November 4, 1994

Enclosed are revisions and additions to the Maryland Department of the Environment, Waste Management Administration's comments (dated September 30, 1994) from technical review of the report entitled "Draft Focused Remedial Investigation Report of the Galaxy/Spectron Site", dated May 4, 1994.

MARYLAND DEPARTMENT OF THE ENVIRONMENT  
WASTE MANAGEMENT ADMINISTRATION  
Comments on the Draft Focused Remedial Investigation  
Report, Galaxy/Spectron Site  
Cecil County, Maryland

MDE Figure 4: Ground Water Contamination Levels In The Angled Wells (From Table 4-7).

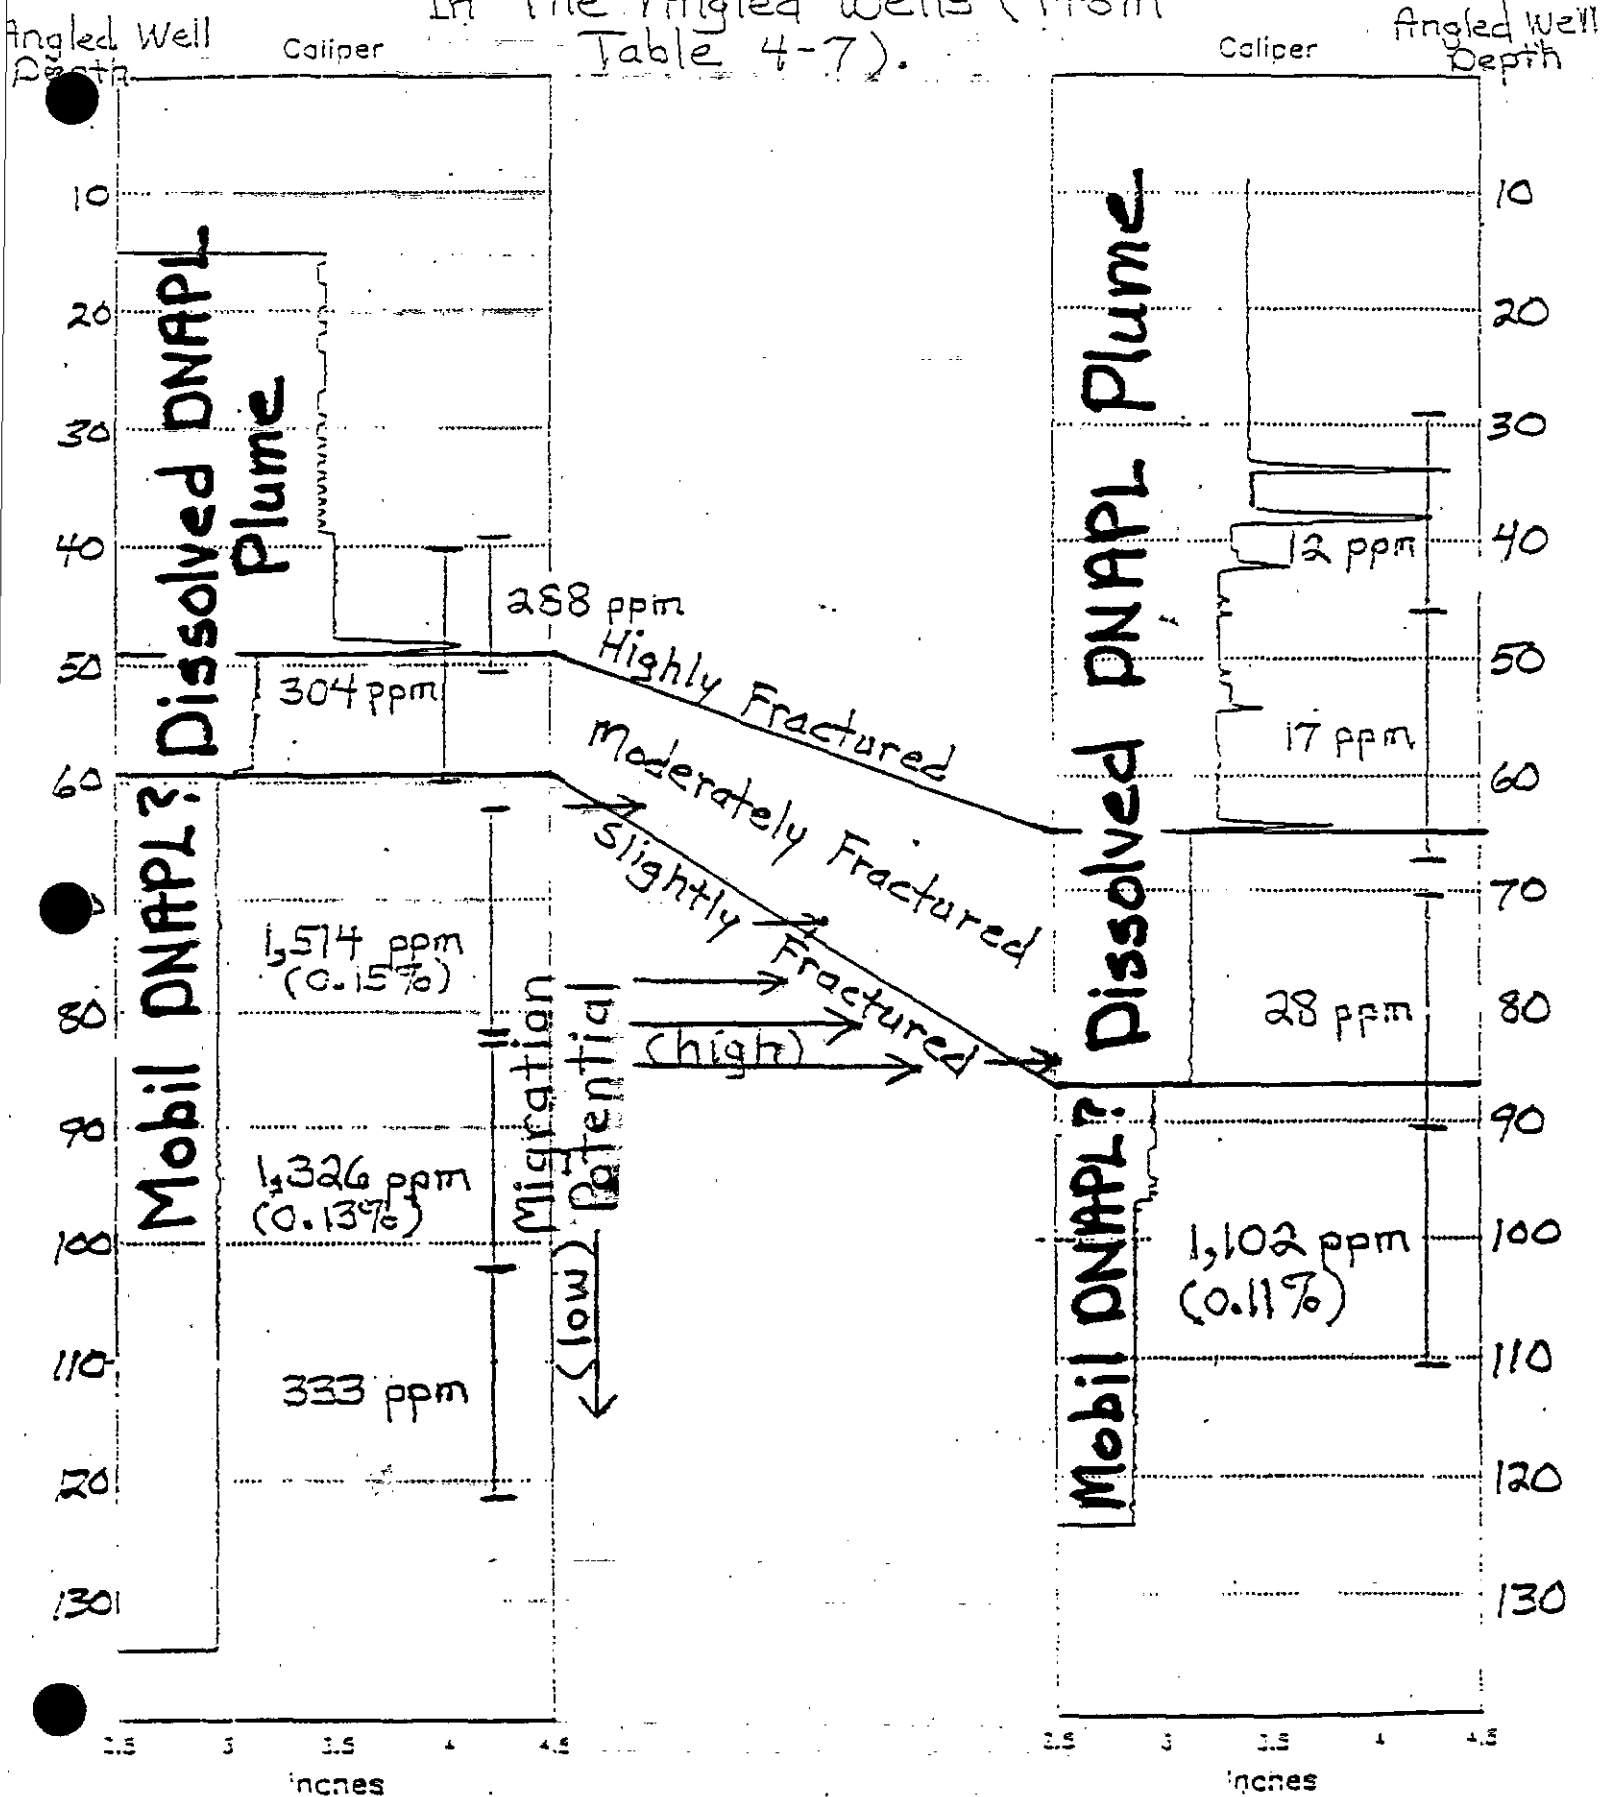
- 3) The strong coincidence of stratification of contaminant concentrations and apparent fracture intensity zones within the bedrock aquifer has significant implications on contaminant migration within the bedrock (MDE Figure 4). The much higher total VOC concentrations in the "slightly fractured" zones of both AW-1 and AW-2 suggests that some of the fractures contain mobile Dense Non-Aqueous Phase Liquid (DNAPL) compounds. Because of increased overburden confining pressure with depth, fracture apertures and fracture intensity generally decrease with depth. The significant reduction in total VOC concentrations below 100 feet in AW-1 suggests that further downward migration of potential mobile DNAPL compounds is not likely. The zone from approximately 60 feet to 100 feet in AW-1 and below 87 feet in AW-2 apparently represents a perched DNAPL reservoir system in pseudo-equilibrium with respect to further downward migration.

Because of significant differences in the thickness of the "highly fractured" and "moderately fractured" zones in AW-1 and AW-2, there is a high potential for lateral migration of mobile DNAPL compounds from the "slightly fractured" zone in AW-1 to the "moderately fractured" zone in AW-2. Actual DNAPL migration

# Fracture Zones, Spectron Site

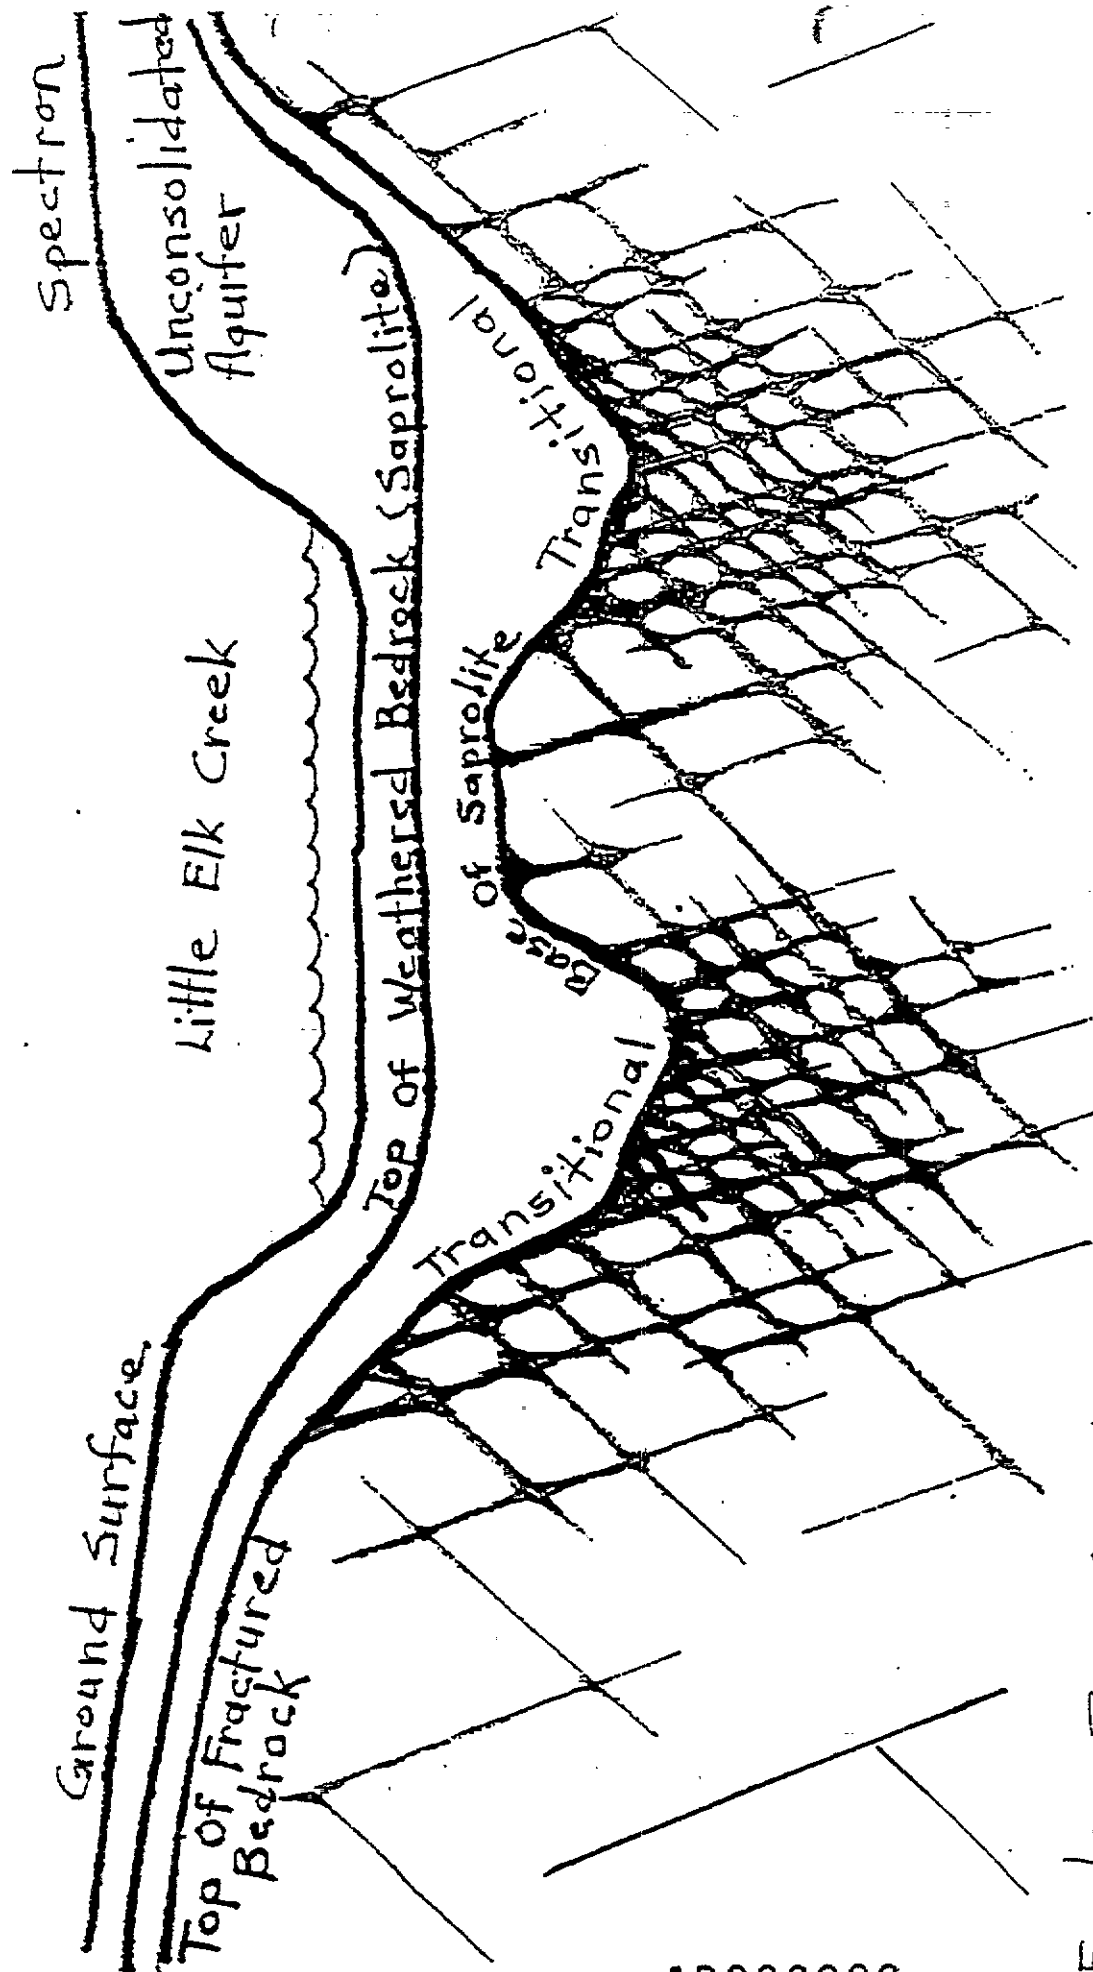
A generalized conceptual model of the subsurface stratigraphy and bedrock fracture zones is presented in MDE Figure 5. This model was constructed to honor all site specific subsurface data which has been gathered to date, and to provide a possible model for contaminant distribution and lateral migration in the bedrock aquifer.

Available site-specific subsurface data was compiled into a possible conceptual model to explain both the contaminant distribution and the petrophysical parameters of the bedrock aquifer. The enclosed MDE Figure 5 is included as a possible conceptual model for fracture relationships in the bedrock aquifer.
